Subject: REAR CONSOLE LID IS LOOSE	Bulletin No: 09-023/15
	Last Issued: 6/2/2015

- This bulletin supersedes the previous bulletin 09-045/14, issued on 11/24/2014 and 10/23/2014. The APPLICABLE MODEL(S)/VINS, PARTS and WARRANTY INFORMATION have been revised.
- Changes are noted below in Red beside the change bar.

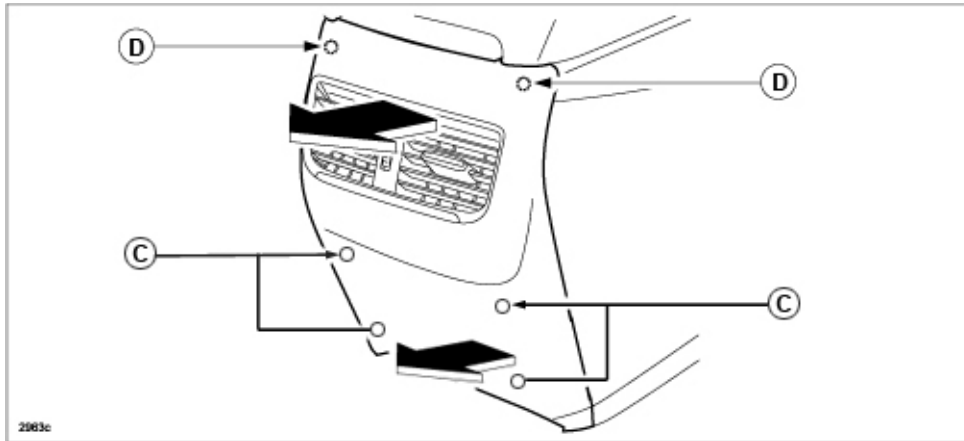
Some customers may complain about a loose rear console lid (A).

This may be caused by hinge pins coming partially off (B) or completely off.

Customers having this concern should have their vehicle repaired using the following repair procedure.

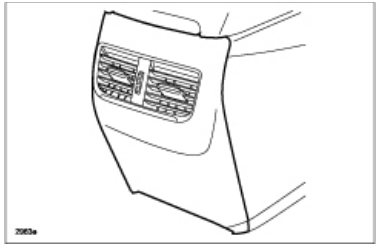
1. Verify customer concern.
2. Remove the rear console panel by pulling in the direction of the arrows shown below.

NOTE: Begin by pulling from the bottom to detach inner attachment clips (C), then continue pulling from the top to detach inner attachment clips (D).

3. Re-install the rear console lid pin(s) back to the original position.

4. Install a new rear console panel. (See PART(S) INFORMATION)

NOTE: The shape of the rear console panel has been changed, by adding a stopper rib to prevent the pin from coming off.
